Buffalo Creek Tributaries Mitigation Project

FINAL VERSION

RE: WLS Responses to NCIRT 30-day Review Comments Regarding Task 3 Submittal, Final Mitigation Plan Approval for the Buffalo Creek Tributaries Mitigation Project, USACE AID# SAW-2018-00425, NCDEQ DMS Full-Delivery Project ID #100042, Contract #7422, Neuse River Basin, Cataloging Unit 03020201, Johnston County, NC

SHEET NUMBER
9

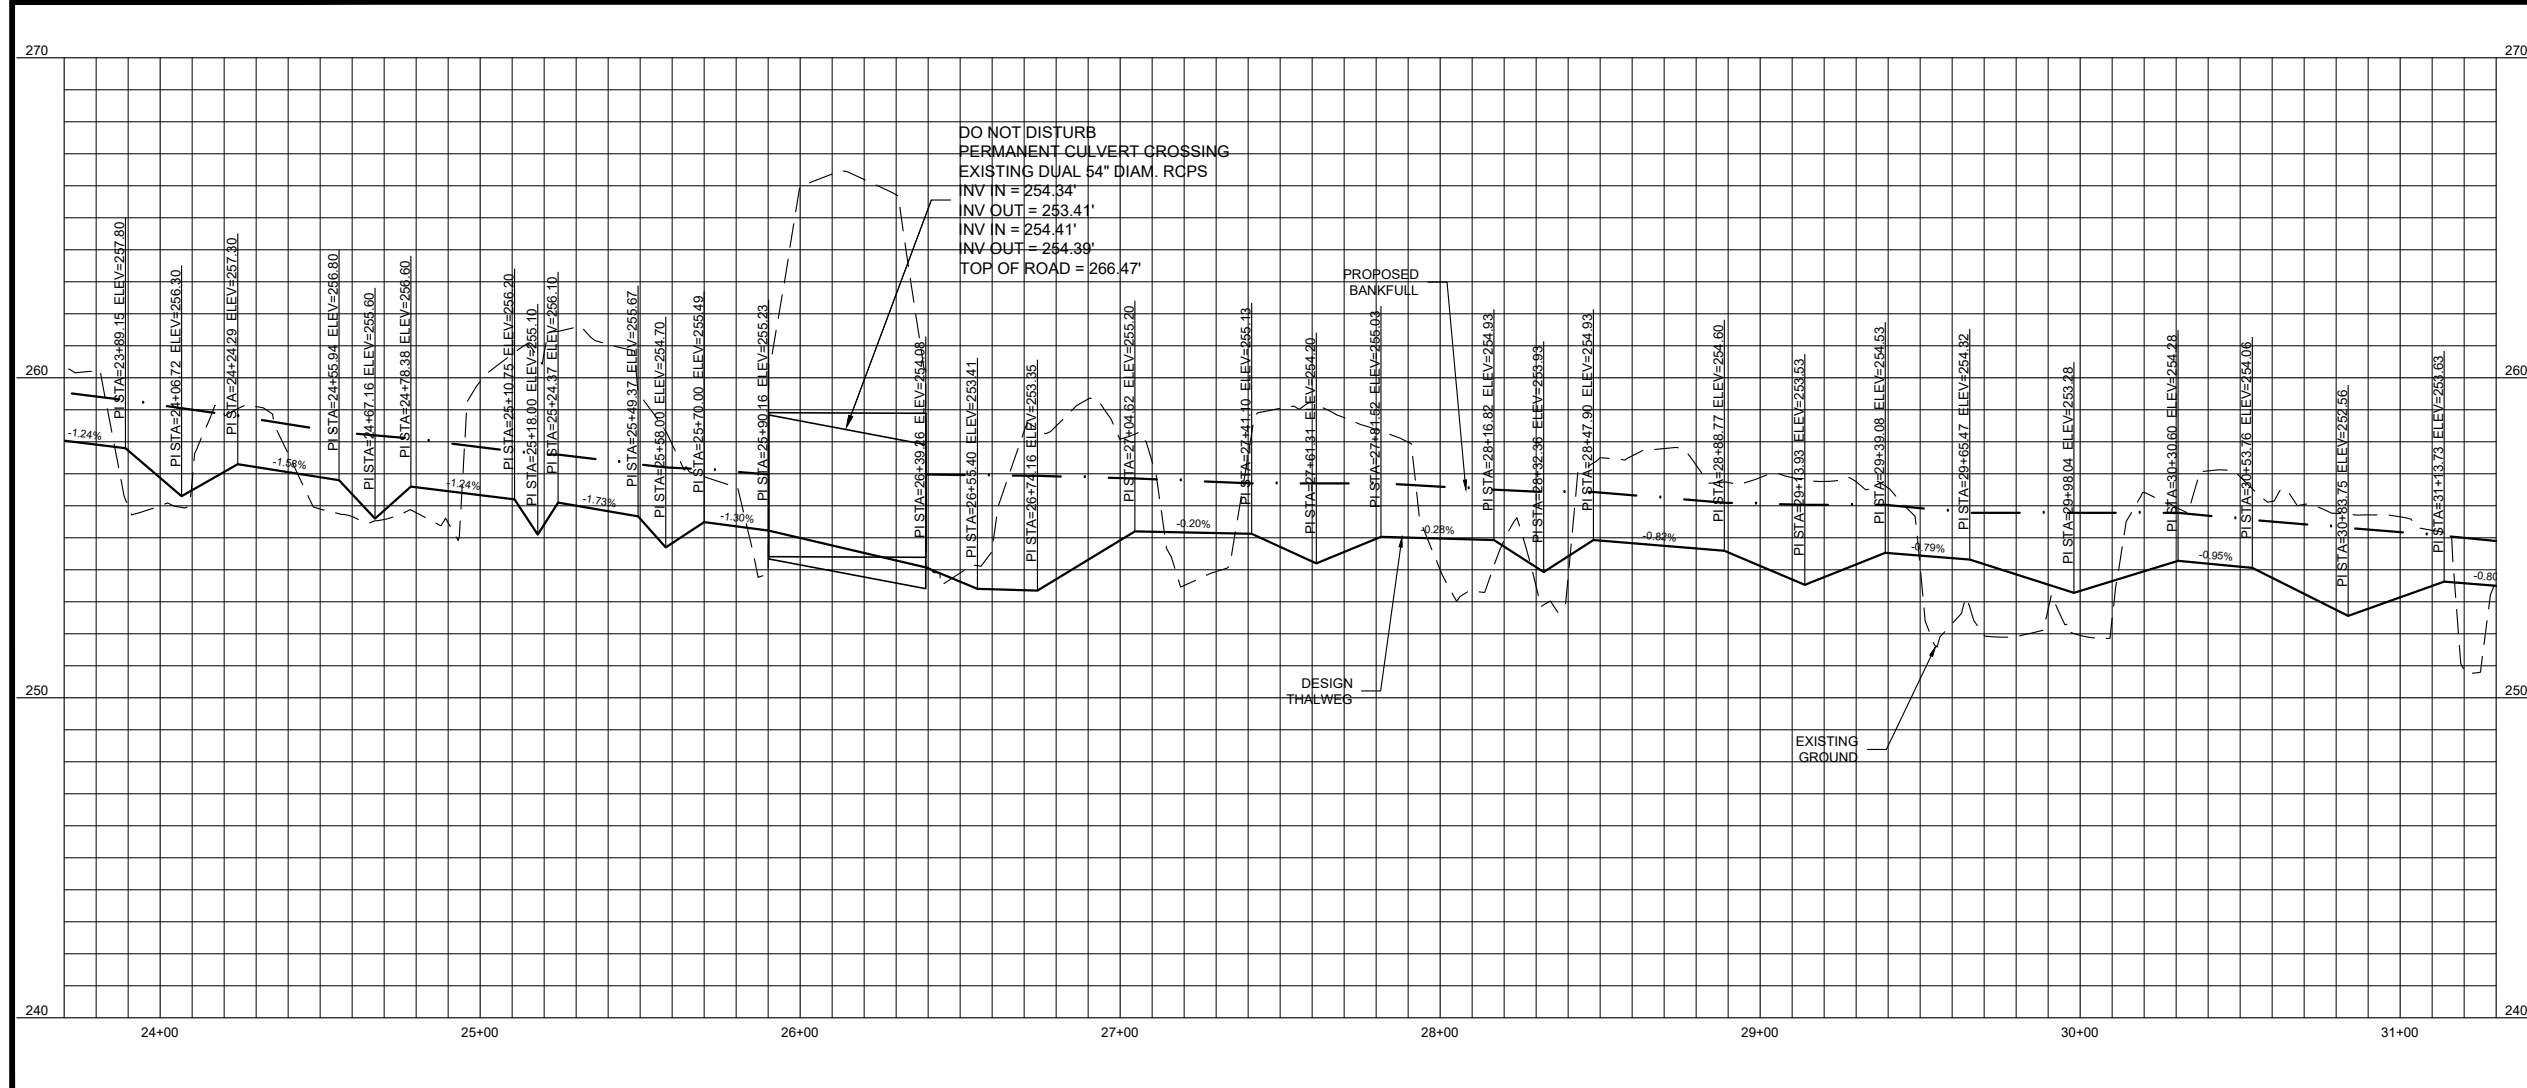
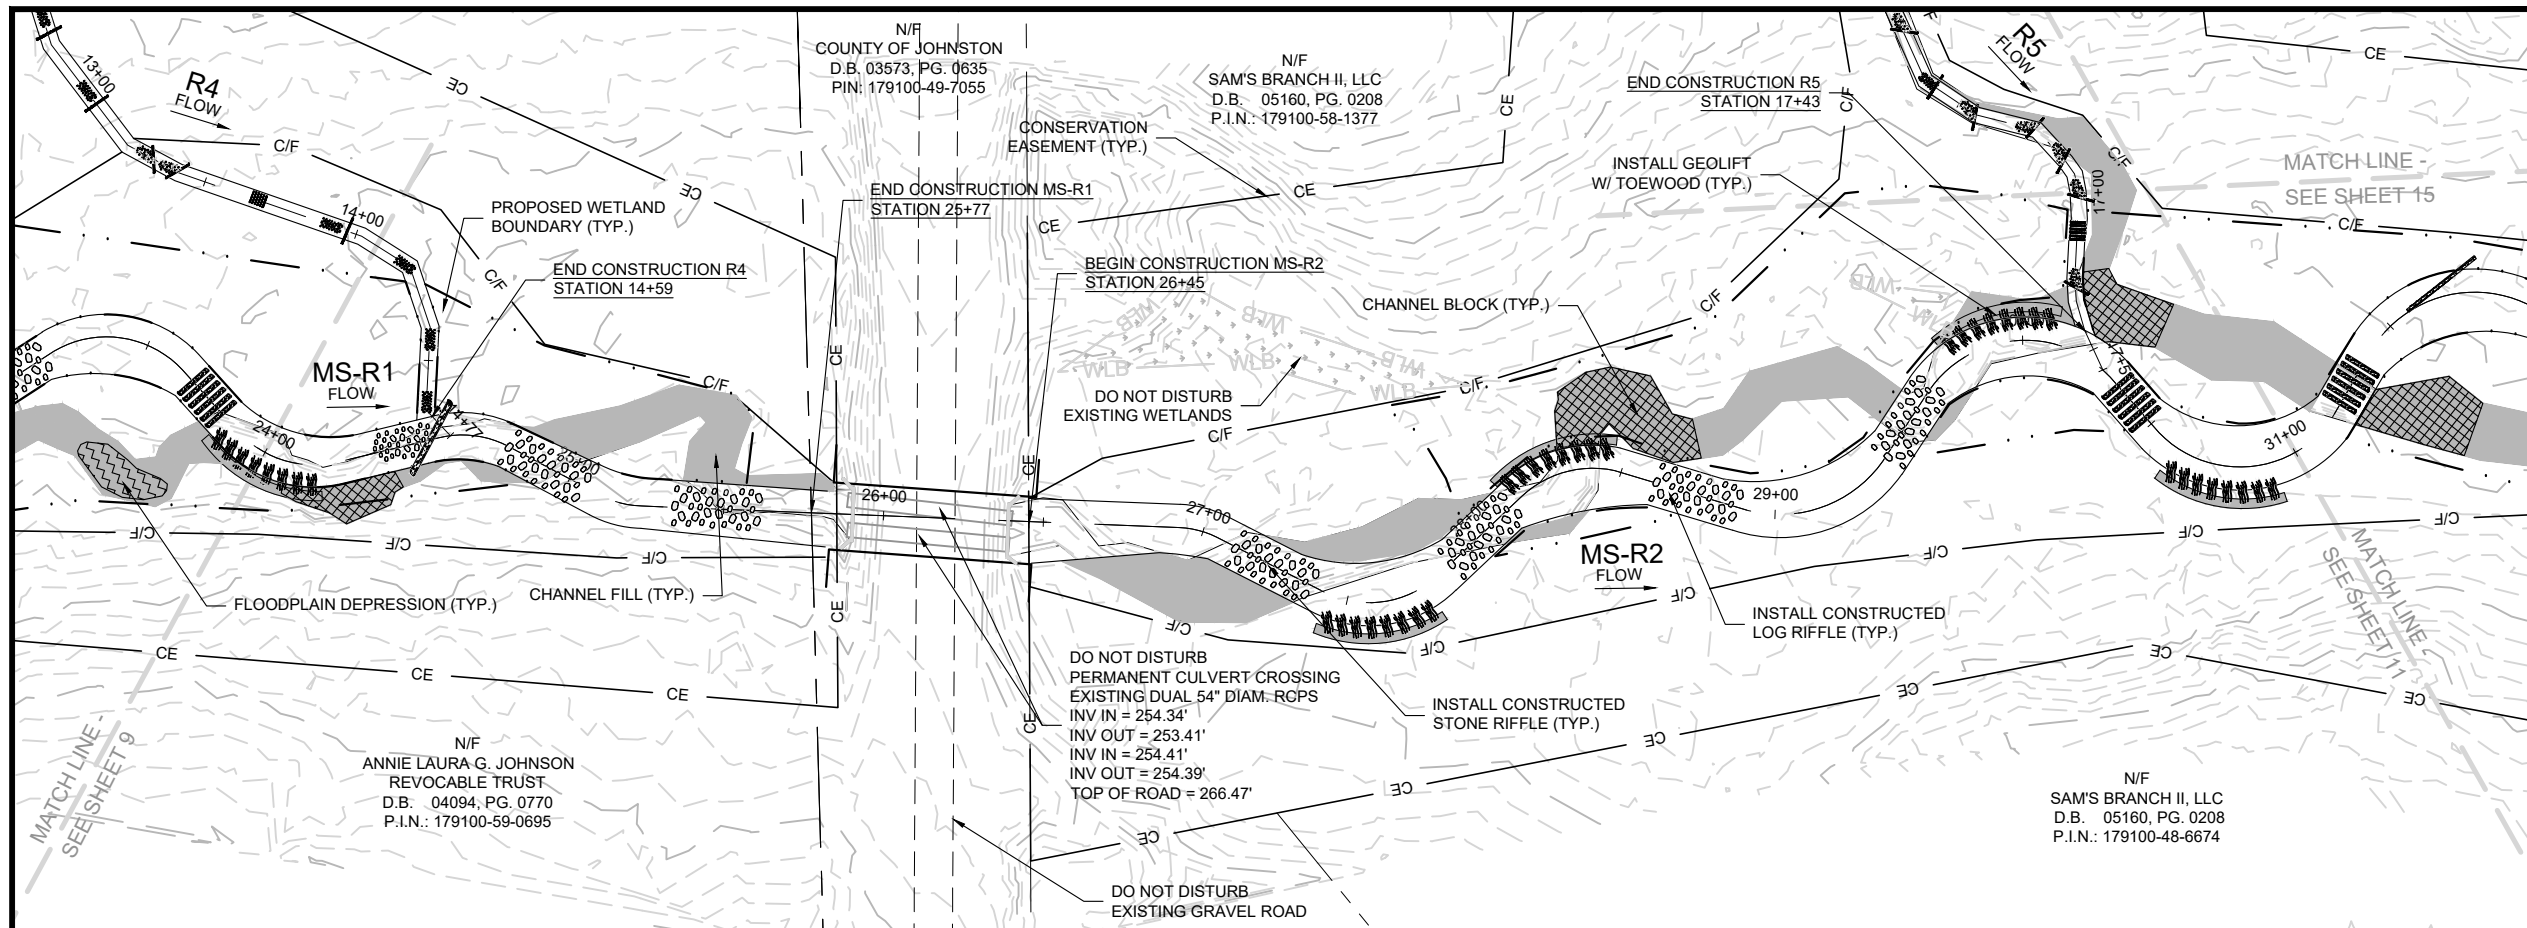
12. Design sheets 8-12- after review of these sheets, it appears that the channel bed is being raised 2-3 feet. Is this correct? DWR is expecting significantly increased overbank flooding to increase the hydrology of the adjacent wetlands. Response: Yes, in many some areas the main channel (MS-R1 and MS-R2) is being raised an average 2-3 feet to accommodate a Priority Level 1 restoration approach. This will likely increase overbank flooding throughout the valley which will increase adjacent wetland hydrology.
